LNE50 SUPPORT COLUMN UPDATE

2021-11-18

INSTALLATION CLASH

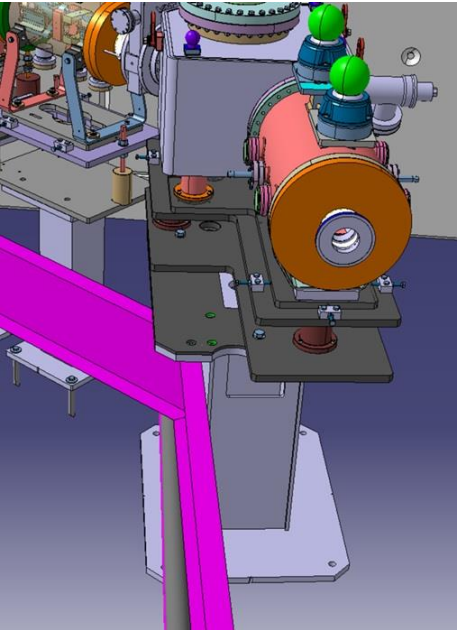
Column left approx. 155 mm away from its installation position due to the cable tray and compressed air line

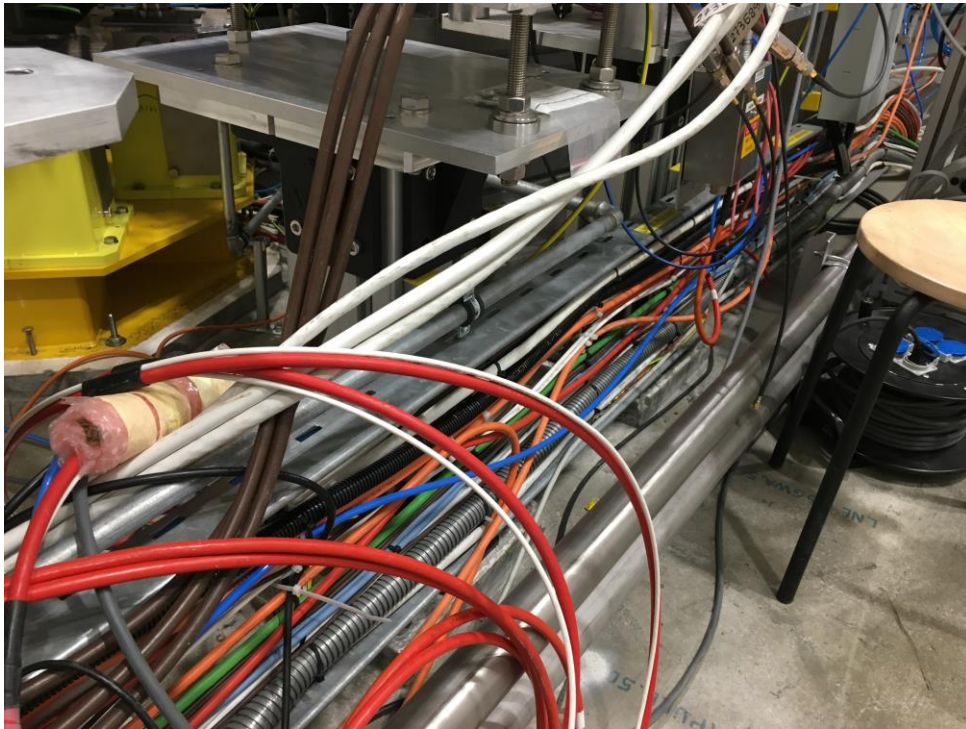
1. Relocate cable tray and relocate and modify the compressed air line
 - EN/EL & EN/CV

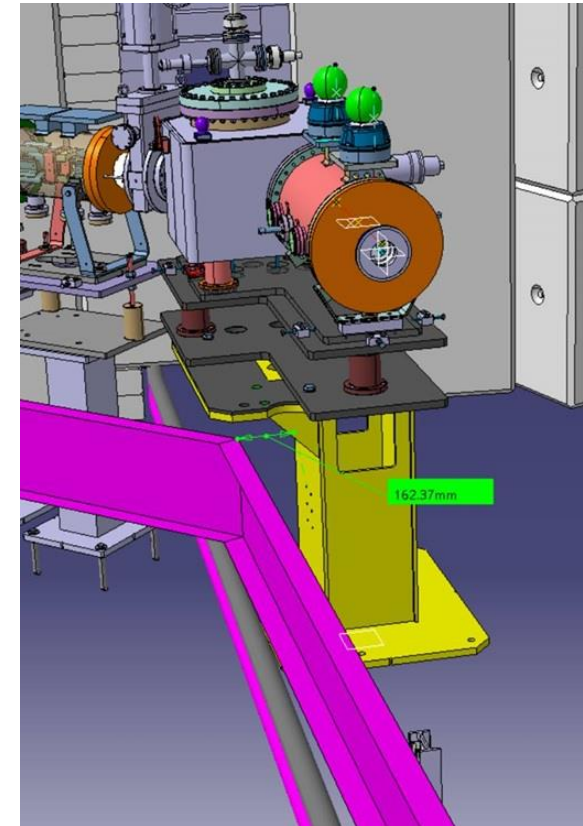
2. Modify the support column
 - EN/MME & EN/ACE

COLUMN MODIFICATION

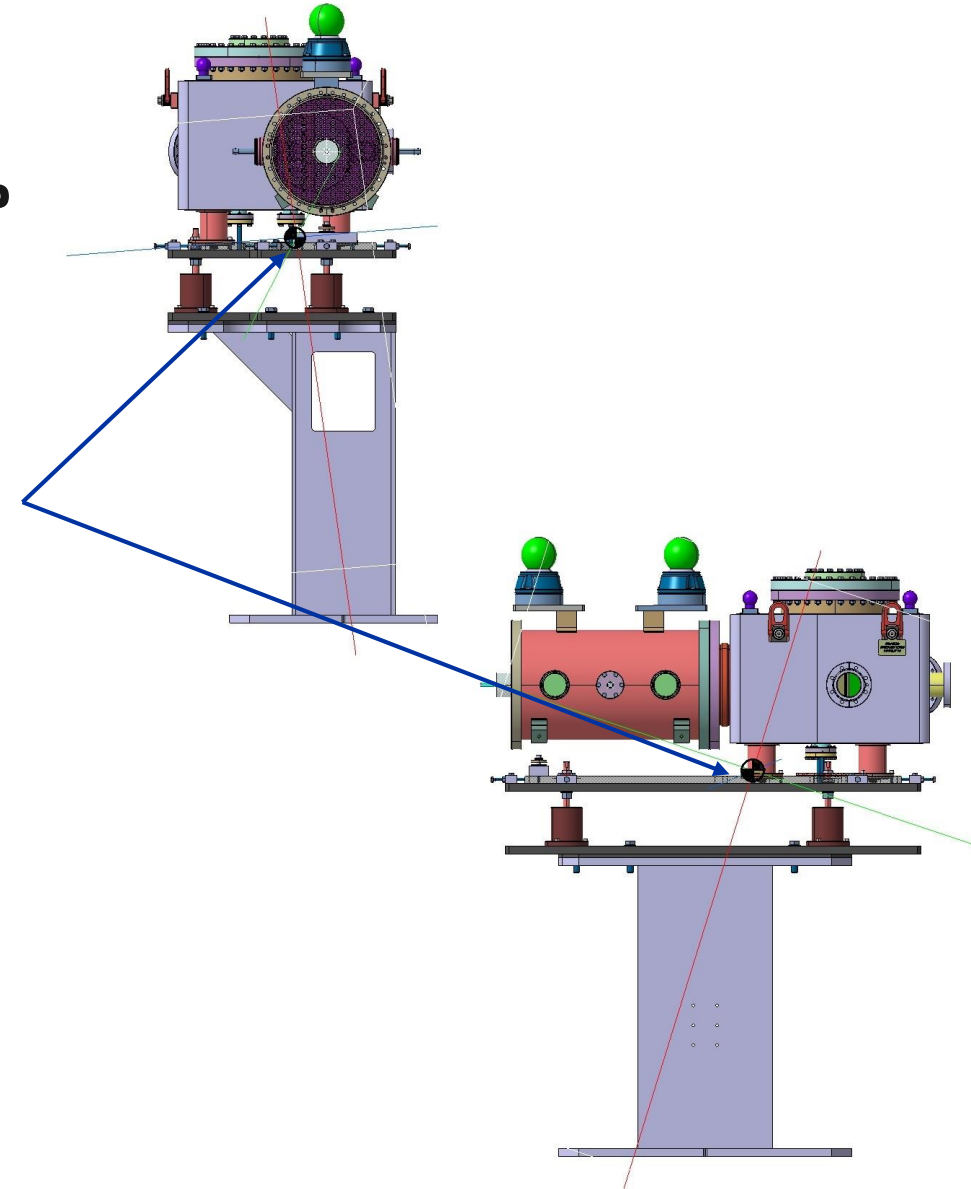
- **SUPPORT MODIFICATIONS BY EN/MME WORKSHOP – FIRST ESTIMATION 5 WORKING DAYS FOR DELIVERY**
- **INSTALLATION CENTRE-OF-GRAVITY REMAINS WELL INSIDE THE FOOTPRINT OF THE MODIFIED COLUMN**
- **INSTALL FOUR NEW ANCHORS TO FIX THE MODIFIED COLUMN – EN/ACE, TRACING OF HOLES BY EN/MME**
 - TRACING 19/11/2021
 - ANCHOR INSTALLATION 19/11/2021 or 22/11/2021 (IMPACT #184505) – curing time 24h
 - INSTALLATION FROM 23/11/2021 or WHEN THE COLUMN IS AVAILABLE

COLUMN MODIFICATION

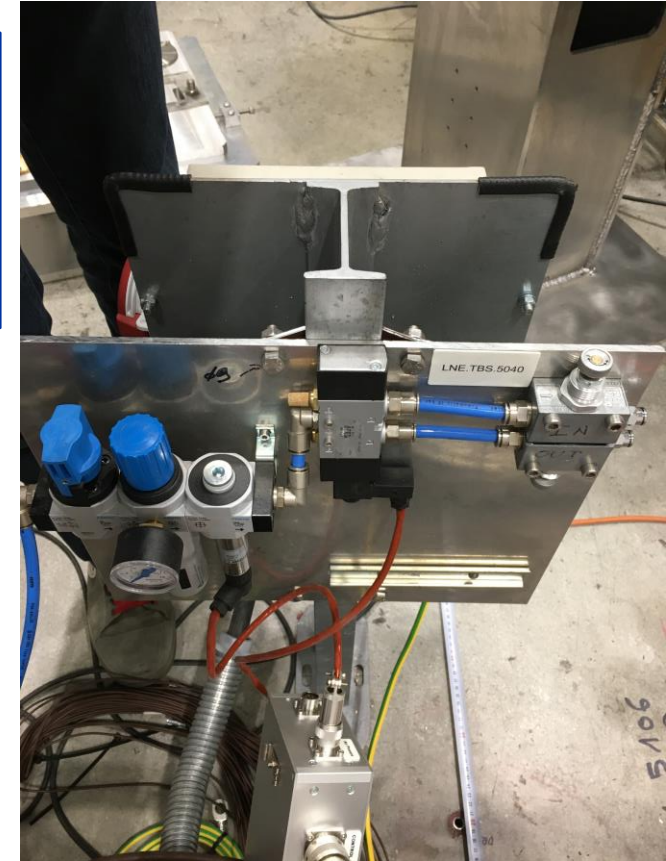
FOR FLOOR WORK THE SHOWN ELECTRICAL BOX/VALVE ASSEMBLY MUST BE MOVED, THE RELEASE OF THE VALVE ASSEMBLY MAY BE ENOUGH TO CREATE THE SPACE – by WHO?

THE CABLES ATTACHED TO THE TRAY SHOULD BE SORTED TO CONFIRM THE INSTALLATION SPACE – by WHO?
